**Bundle of documents for Oral hearings
commencing from 13 May 2025 in relation
to the Queen Elizabeth University Hospital
and the Royal Hospital for Children,
Glasgow**

**Bundle 33
NEC3 Supervisor's Reports and Project
Supervisors Interface Action Notes**

4.3.14 Cladding

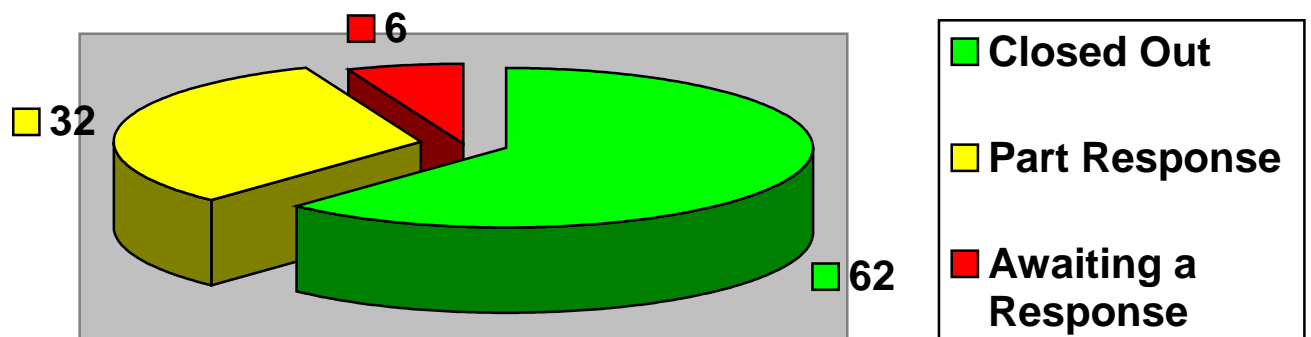
We noted that the installation of the Cladding is ongoing and that there are adjustments to be made to the position of the anchors. We have

asked Brookfield provide further information in relation to the installation and fixing of the cladding (See Supervisor's Communication General Matters / Other Instructions (CI 13.1) No 17).

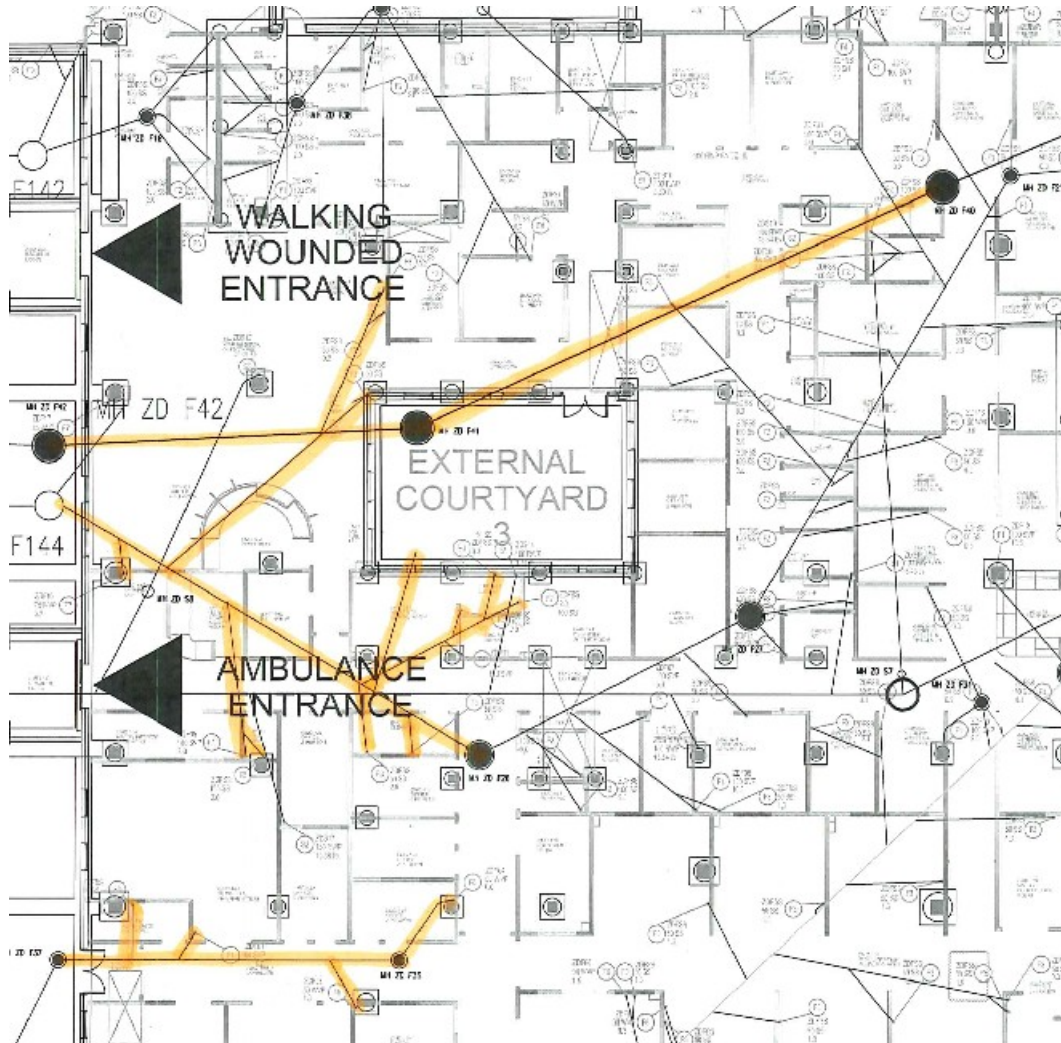
During our visit to site we noted that Zone D below ground drainage did not appear installed as per construction drawings. Consequently we have raised Supervisor's Communication General Matters / Other Instructions (CI 13.1) No 19. Brookfield has responded confirming that they have requested the relevant information from Dunne following a walk round on 21st June 2012.

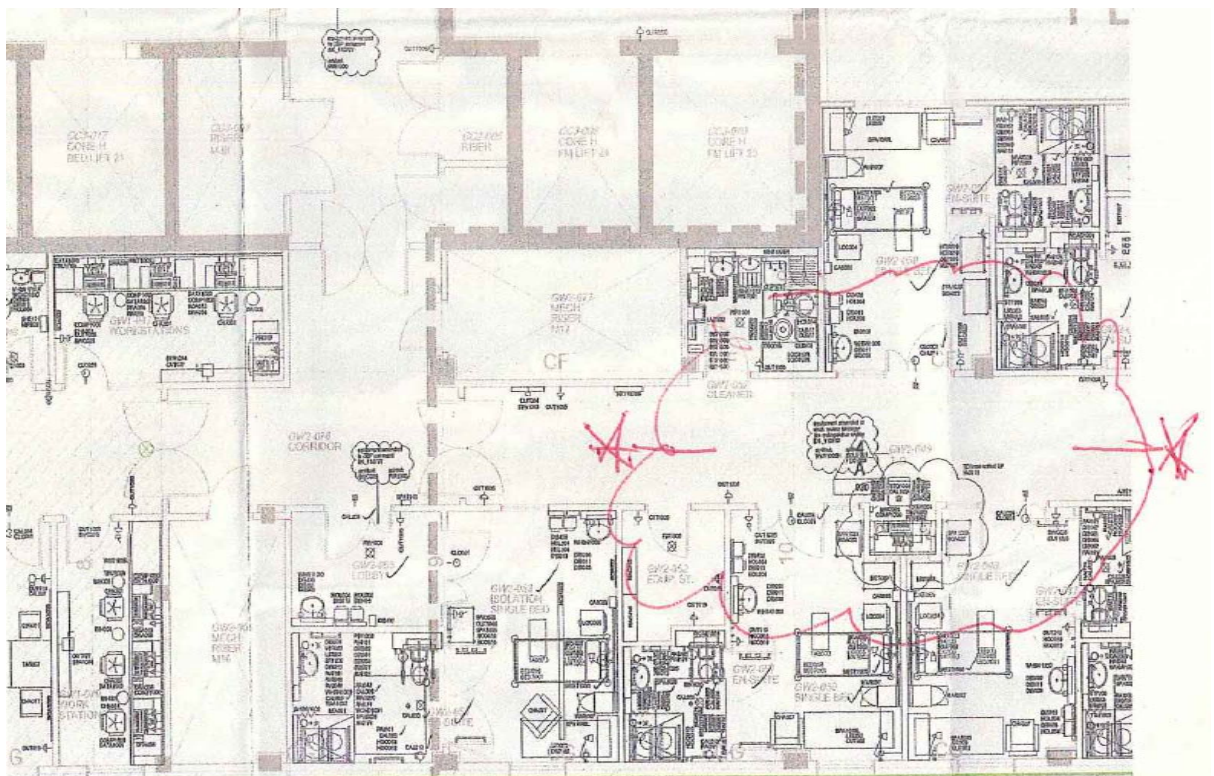
Two access hatches are blocked by containment in the corridor. See photos and location below.

We have asked Brookfield to confirm when appropriate access has been provided so that we can re-inspect the hatches. (See Supervisor's Communication General Matters / Other Instructions (CI 13.1) No 53).

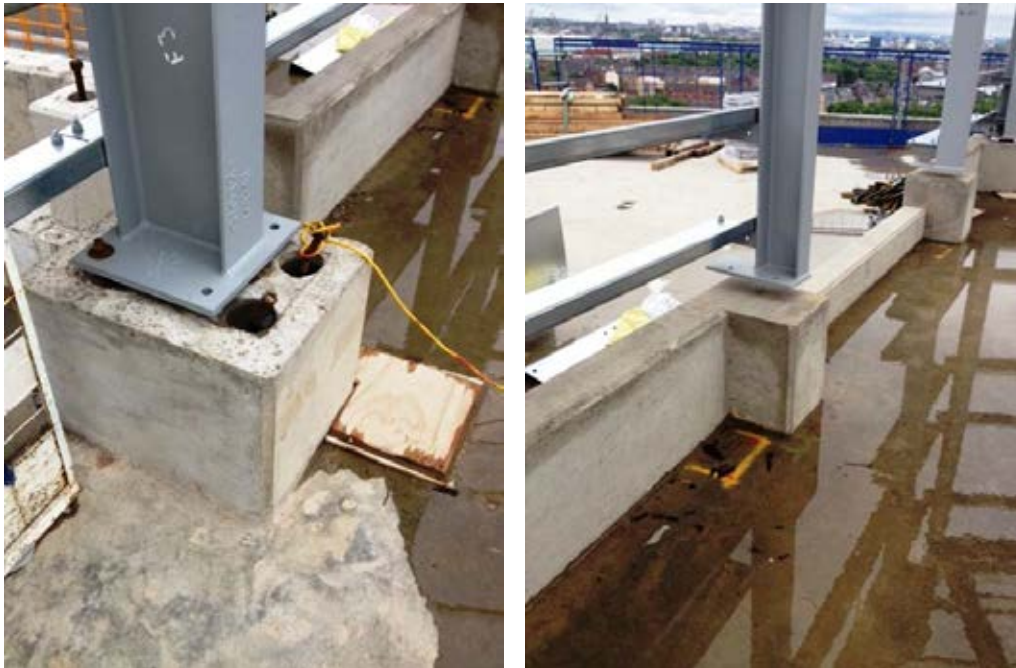
Two internal RHS columns in the Children's Hospital Zone B appear to be held up by adjoining steelwork. This may be work in progress, but we asked Brookfield to confirm the final detailing. Brookfield has informed us that the final detail is a connection to concrete. The concrete works and subsequent bolting up will be undertaken prior to the installation of any cladding. See Supervisor's Communication General Matters / Other Instructions (CI 13.1) No 118.

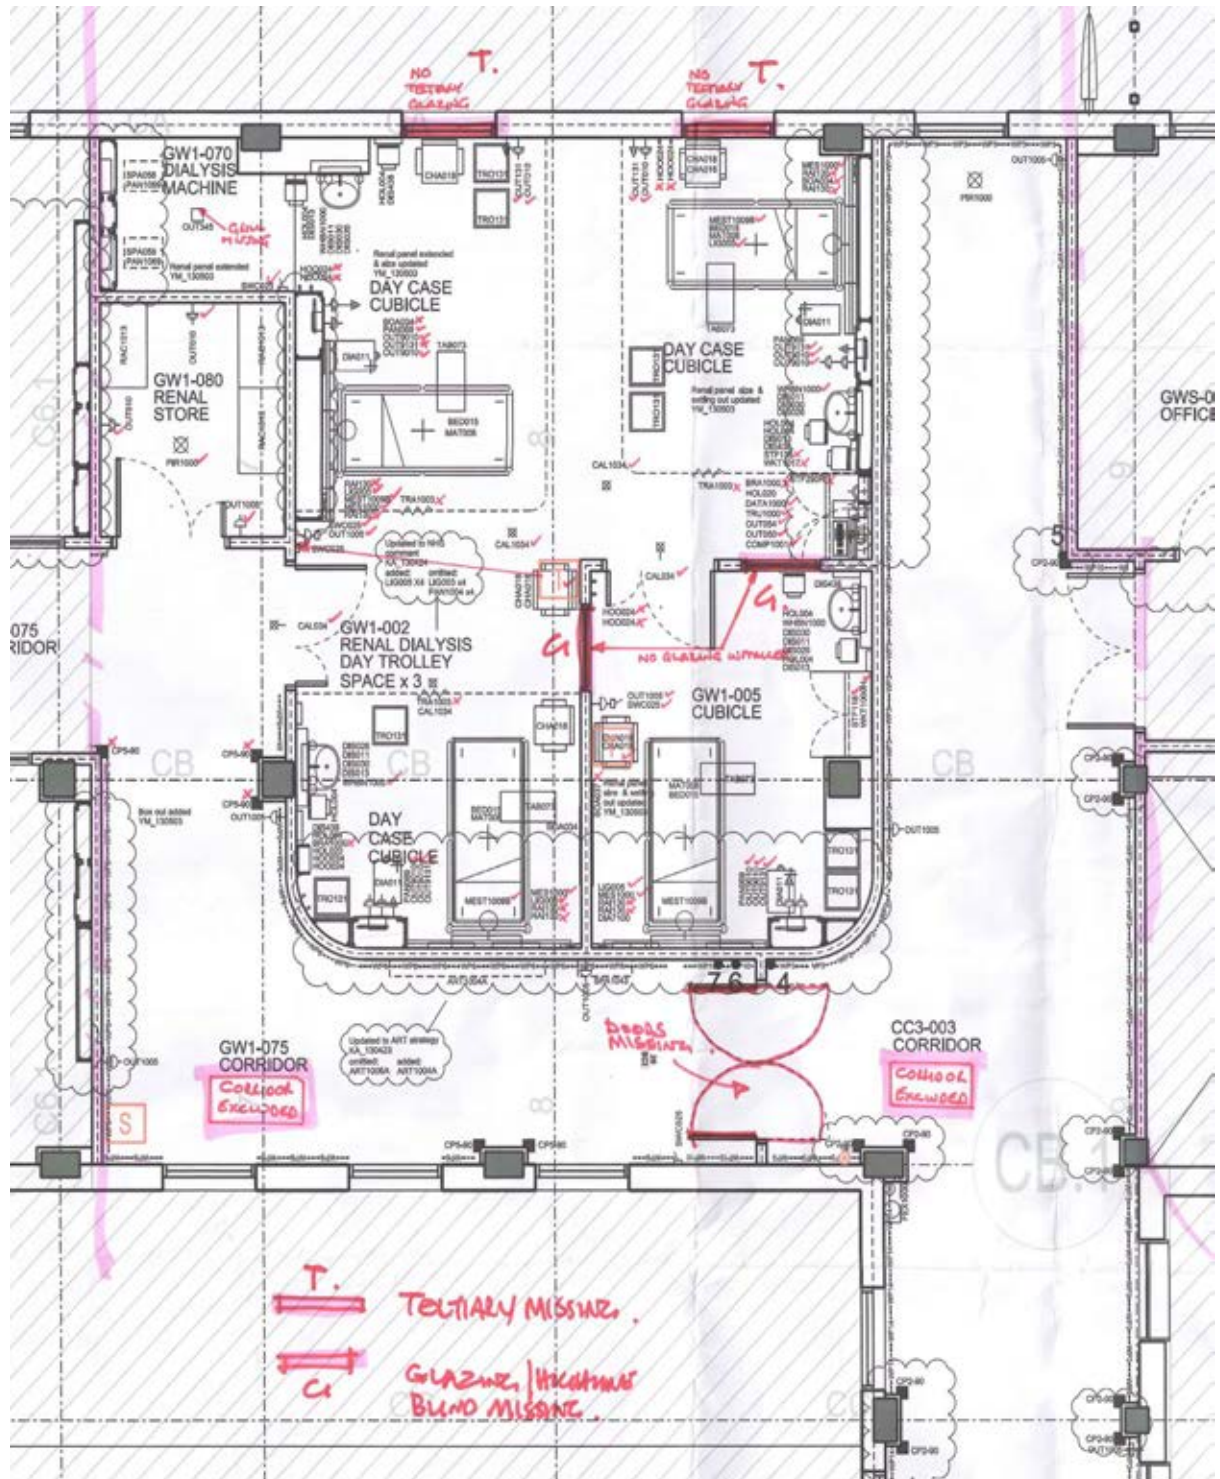
The red line drawing below shows the status of the work at the time of inspection on 19/05/14 and identifies incomplete work. Items ticked are fitted and those with a cross are still to be fitted.

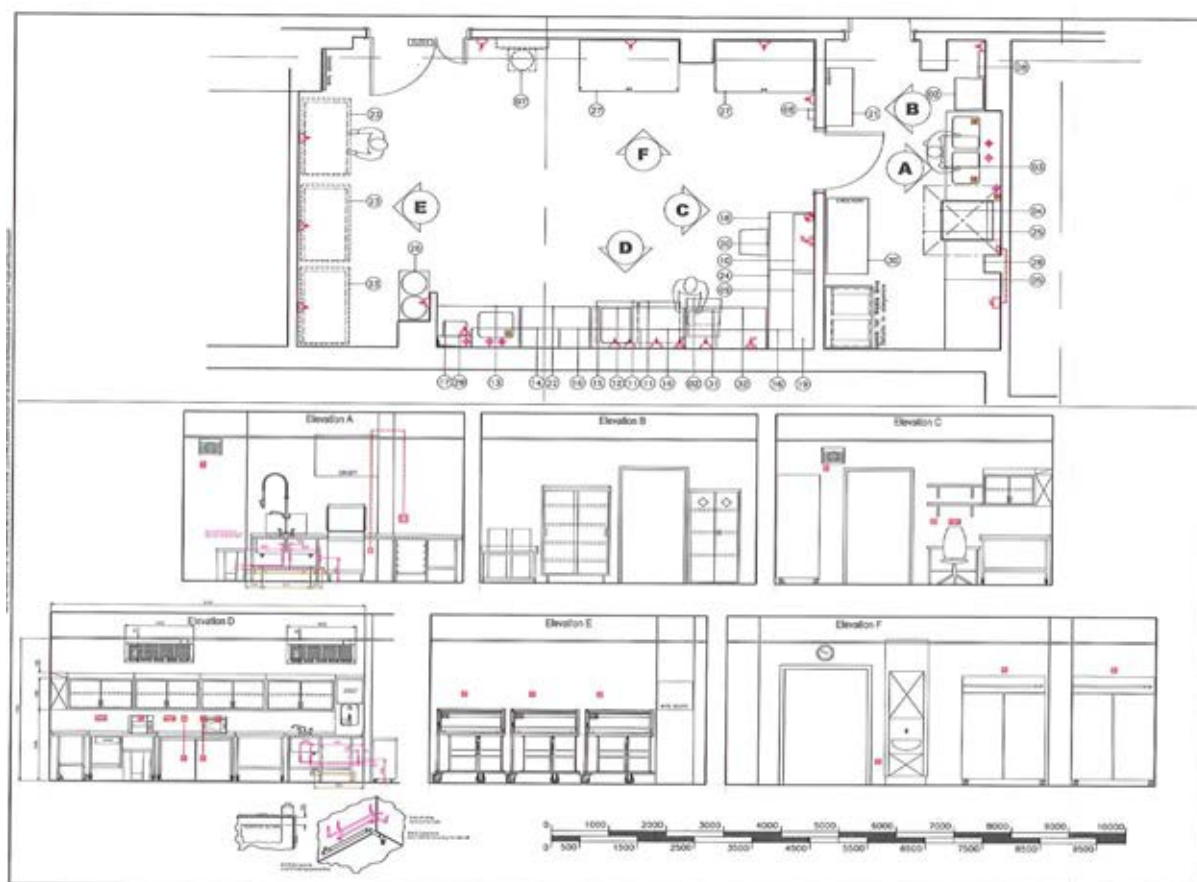
Below is a marked up reflected ceiling plan showing the services which are either in their correct position or require to be moved.
